Access Compliance Report

Public Rights-of-Way

Intersection ID: 10038783	Main Street: STEELE_CREEK_RD	Cross Street: N/A	Location: NW
ADA ID: A50E593A4C1A	Ramp Type: Combination1Diag	Initial Pass/Fail: Fail	Overall Compliance: No
		Severity Score: 0

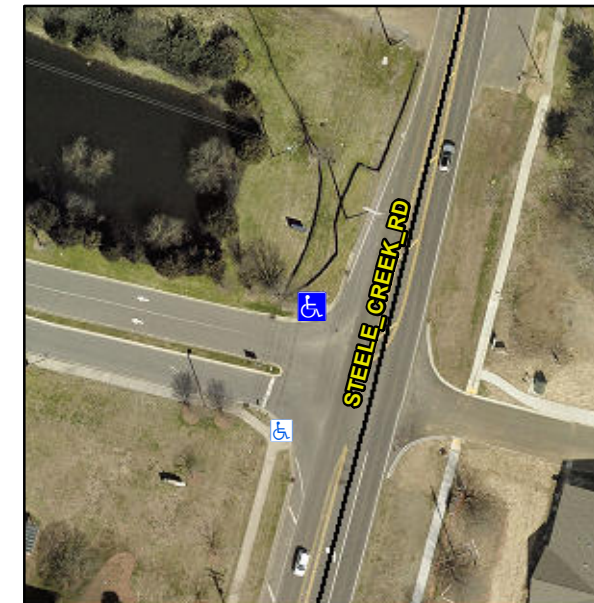
RT RP < 5%

R304.5.3, R304.3.2

Compliance	Description	Data	Compliance	Description	Data
N/A	Ramp Length LT (in)	56.0	N/A	Ramp Length RT (in)	42.0
Yes	Ramp Width LT (in)	59.0	Yes	Ramp Width RT (in)	60.0
No	Ramp Slope LT (%)	11.3	Yes	Ramp Slope RT (%)	3.2
Yes	Ramp XSlope LT (%)	0.6	No	Ramp XSlope RT (%)	5.5
N/A	Ramp Length (in)	35.0	Yes	Ramp Slope (%)	5.7
Yes	Ramp Width (in)	51.0	No	Ramp XSlope (%)	5.6
N/A	Flare Type LT	N/A	N/A	Flare Type RT	N/A
N/A	Flare Slope LT (%)	N/A	N/A	Flare Slope RT (%)	N/A
N/A	Flare Traversable LT?	N/A	N/A	Flare Traversable RT?	N/A
N/A	Landing Length (in)	N/A	N/A	DWS Provided?	N/A
N/A	Landing Width (in)	N/A	N/A	DWS Contrast?	N/A
N/A	Landing Slope (%)	N/A	N/A	DWS Length (in)	N/A
N/A	Landing X Slope (%)	N/A	N/A	DWS Full Width?	N/A
N/A	Landing Curb? (Y/N)	N/A	N/A	DWS Offset (in)	N/A
N/A	Shared Landing?	N/A			
N/A	Gutter Ponding?	N/A	N/A	Gutter Slope (%)	N/A
N/A	Gutter Lip Ht (in)	N/A	N/A	Gutter X Slope (%)	N/A
N/A	Painted X Walk1?	No	N/A	Painted X Walk2?	No

Remove & Replace Curb Ramp With Two New Directional Ramps or Equivalent.
